# Access Compliance Report

## Public Rights-of-Way

### (Curb Ramps)

Intersection ID: 13420	Main Street: S_TRYON_ST	Cross Street: W_BLAND_ST	Location: S
ADA ID: 03992AFA54DF	Ramp Type: BlendTrans2	Initial Pass/Fail: Fail	Overall Compliance: No
Severity Score: 47.5			
Codes/Mitigation Info/Possible Solution		Field Measurements/Component Compliance

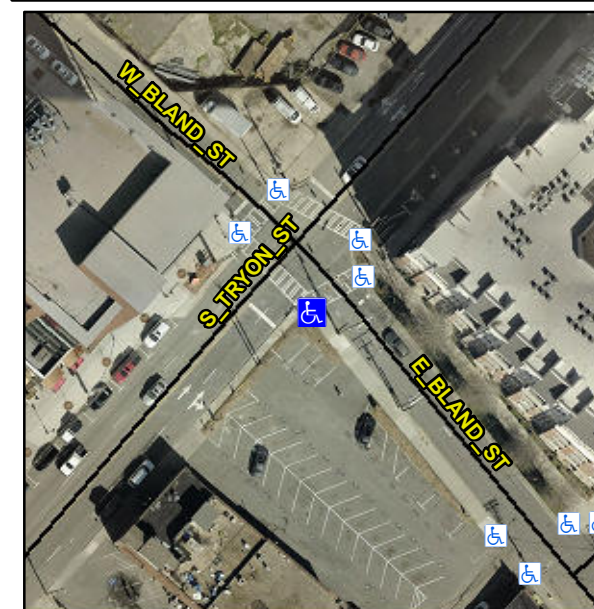
**Not Found, R304.5.1, R304.5.3**

Compliance	Description	Data	Compliance	Description	Data
N/A	Ramp Length (in)	82.0	Yes	BlendTrans Slope (%)	2.3
No	Ramp Width (in)	28.0	No	BlendTrans XSlope (%)	6.0
N/A	Flare Type LT	N/A	N/A	Flare Type RT	N/A
N/A	Flare Slope LT (%)	N/A	N/A	Flare Slope RT (%)	N/A
N/A	Flare Traversable LT?	N/A	N/A	Flare Traversable RT?	N/A
N/A	Landing Length (in)	N/A	N/A	DWS Provided?	N/A
N/A	Landing Width (in)	N/A	N/A	DWS Contrast?	N/A
N/A	Landing Slope (%)	N/A	N/A	DWS Length (in)	N/A
N/A	Landing X Slope (%)	N/A	N/A	DWS Full Width?	N/A
N/A	Landing Curb? (Y/N)	N/A	N/A	DWS Offset (in)	N/A
N/A	Shared Landing?	N/A			
N/A	Gutter Ponding?	N/A	N/A	Gutter Slope (%)	N/A
N/A	Gutter Lip Ht (in)	0.5	N/A	Gutter X Slope (%)	N/A
N/A	Painted X Walk1?	Yes	N/A	Painted X Walk2?	Yes
	X Walk 1 Direction	To NE		X Walk 2 Direction	To NW
	X Walk 1 Width (in)	107.0		X Walk 2 Width (in)	96.0
	X Walk 1 Slope (%)	7.6		X Walk 2 Slope (%)	5.5
	X Walk 1 X Slope (%)	4.6		X Walk 2 X Slope (%)	3.0

N/A	Ramp inside XWalk1?	Yes	N/A	Ramp inside XWalk2?	Yes
	Road Slope (%)	3.0		Clear Space?	N/A
	Road X Slope (%)	5.4	N/A	Clear Space to XWalk (in)	N/A
N/A	Any Obstructions?	N/A	N/A	Storm Grate/Utility Hazard?	N/A
	Obstruction Type			Storm Grate/Utility Type	
		N/A			N/A
		Yes		Surface Condition? (G/P)	Good
		No		Curb Slope (%)	6.6

**Remove & Replace Curb Ramp With Two New Directional Ramps or Equivalent.**
